# HISTORIC AND DESIGN REVIEW COMMISSION

February 15, 2023

**HDRC CASE NO:** 2023-038  
**ADDRESS:** 202 N ST MARYS ST  
130 N ST MARYS ST  
**LEGAL DESCRIPTION:** NCB 405 BLK LOT N 109.8 FT OF 1 & 2  
NCB 405 (SAA- OMI TRACT), LOT 10  
**ZONING:** D, HE, RIO-3  
**CITY COUNCIL DIST.:** 1  
**LANDMARK:** Individual Landmark  
**APPLICANT:** Anthony Byron  
**OWNER:** St Mary's Catholic Church  
**TYPE OF WORK:** Construction of a 17-story hotel tower  
**APPLICATION RECEIVED:** January 31, 2023  
**60-DAY REVIEW:** Not applicable due to City Council Emergency Orders  
**CASE MANAGER:** Edward Hall  
**REQUEST:**

The applicant is requesting a Certificate of Appropriateness for approval to construct a hotel tower to feature seventeen stories, not including the river level, to feature an overall height of approximately 203 feet. The proposed hotel received final approval in May 2019 but has since been amended regarding height.

Solar Studies: Winter

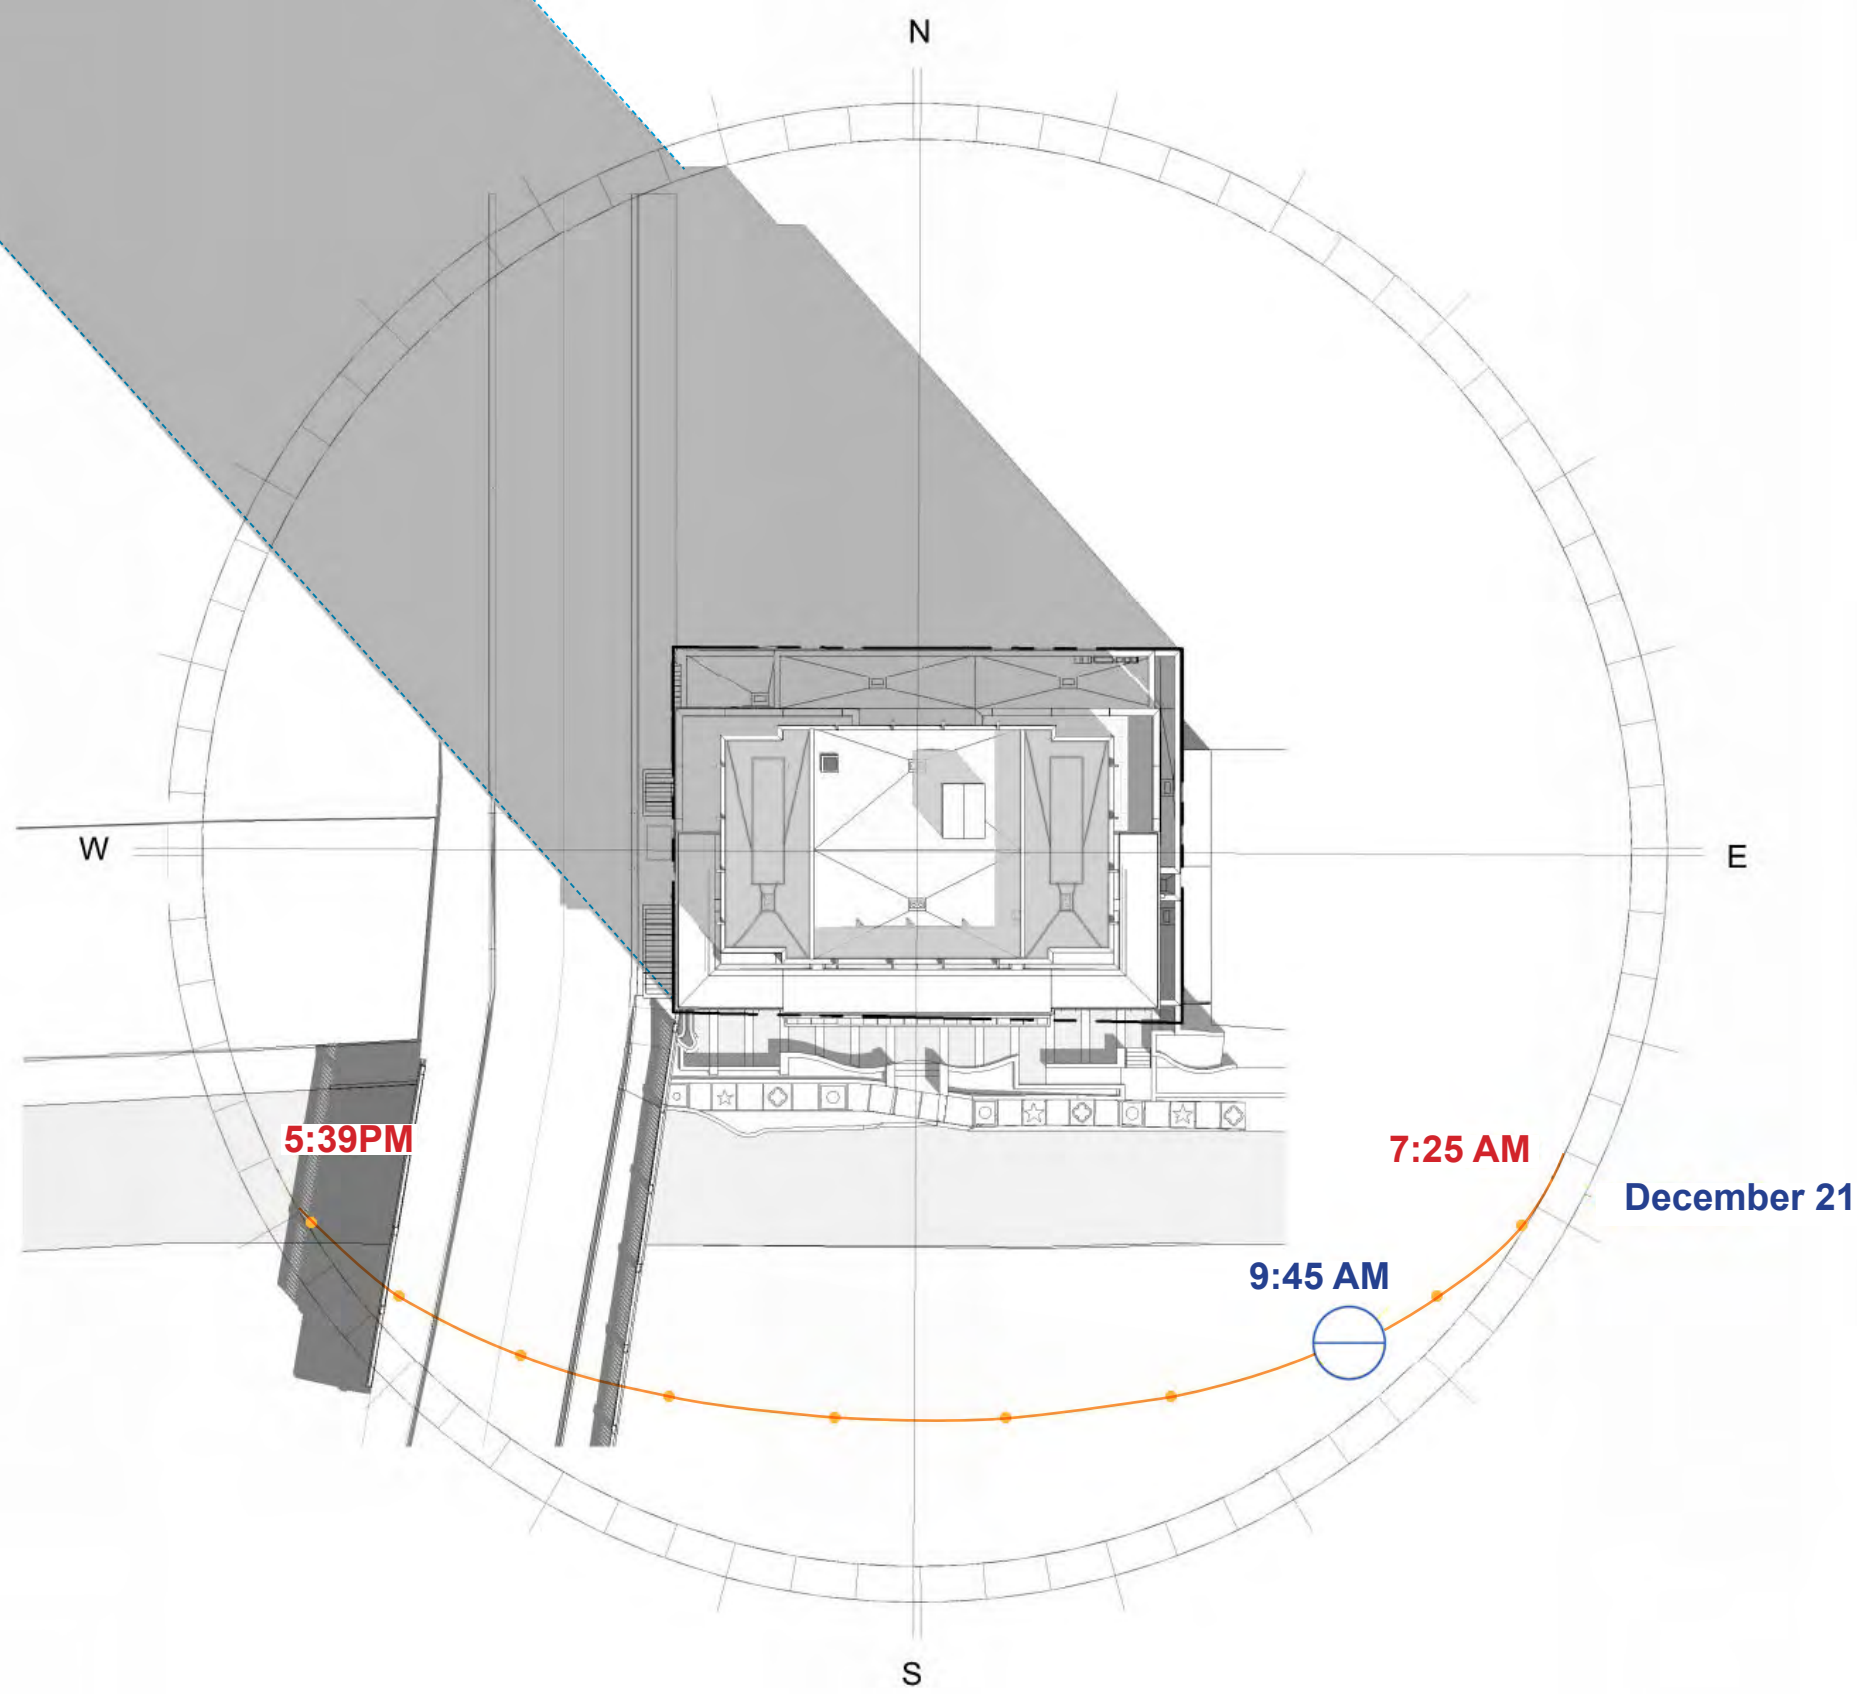
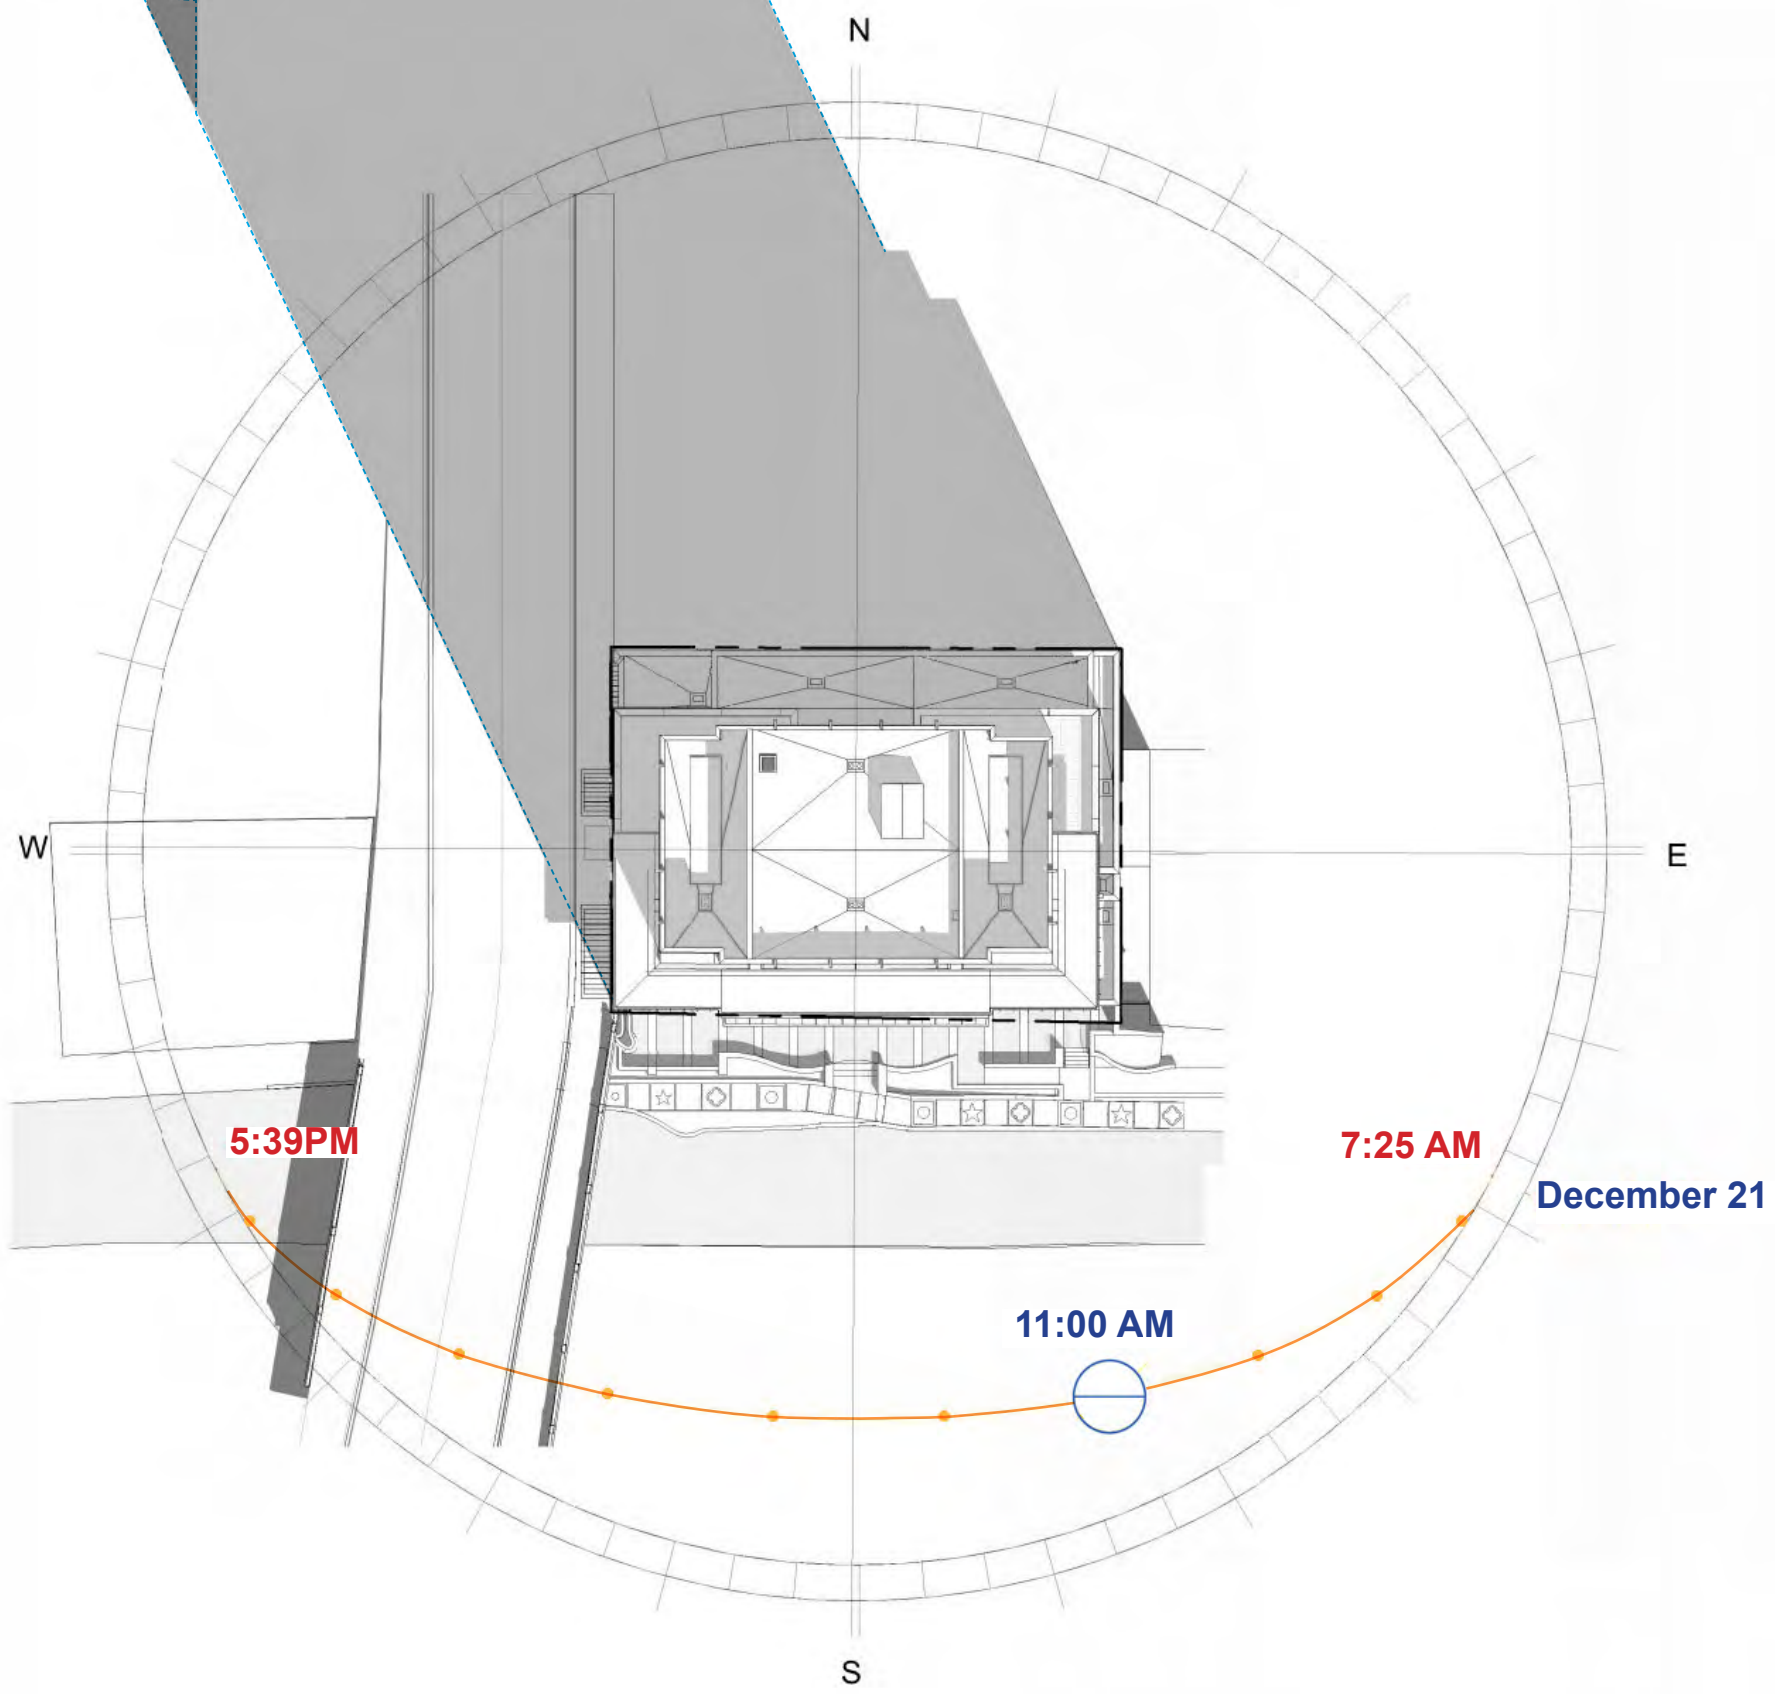
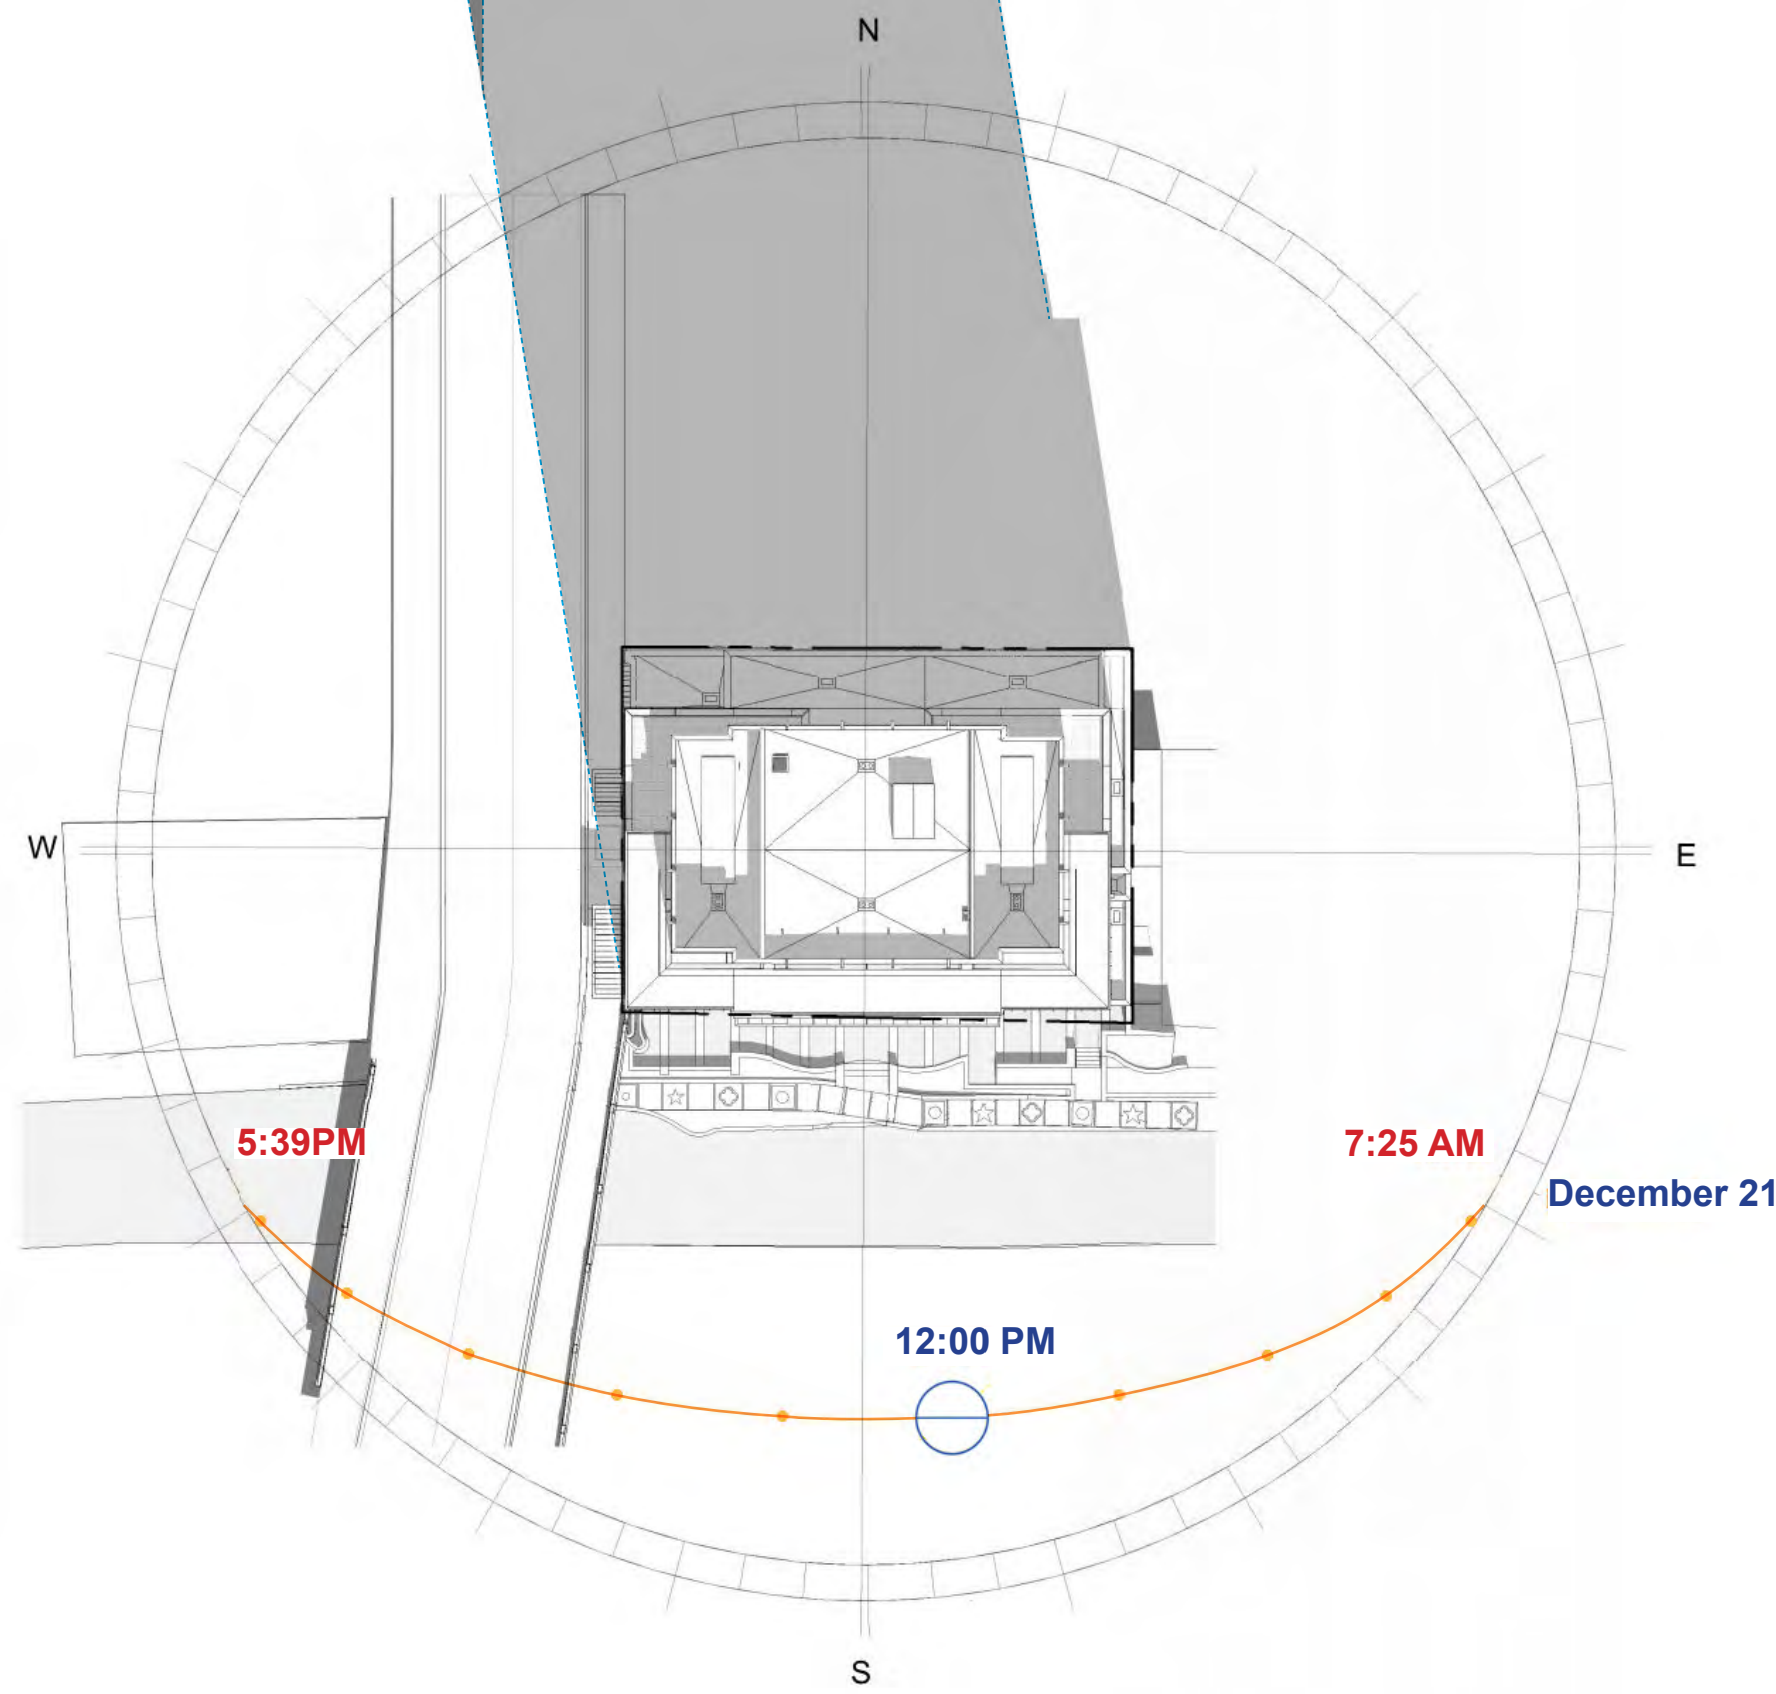
- ix. Ensure adequate solar access on the River Walk.
